SERVICE BULLETIN 12

SUBJECT: F3416M ROD END BEARINGS

APPLICATION: Service Bulletin 12 applies to Glasair airframe kits through serial number 795. This includes kits shipped on or before 4/30/86.

FIGURE (1)

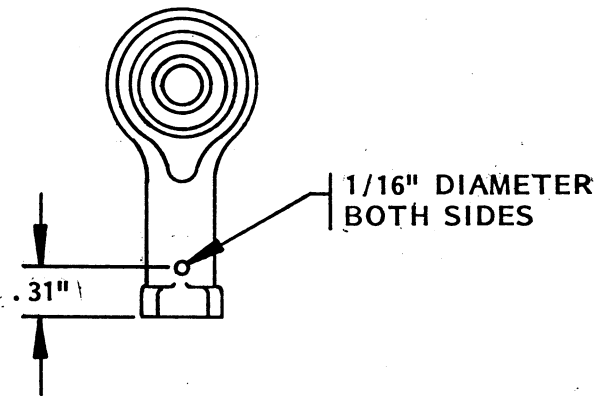
DESCRIPTION: Some of the F3416M rod end bearings shipped with recent kits lack the two small inspection holes that are necessary to determine if the rod ends are threaded onto their actuator rods sufficiently.

The rod end bearings must be modified to allow inspection for adequate threading onto the rod ends. Using a 1/16" drill bit, drill holes through both sides of the rod end bearing. Locate the holes .31" from the threaded end of the bearing, as shown in FIGURE (1).
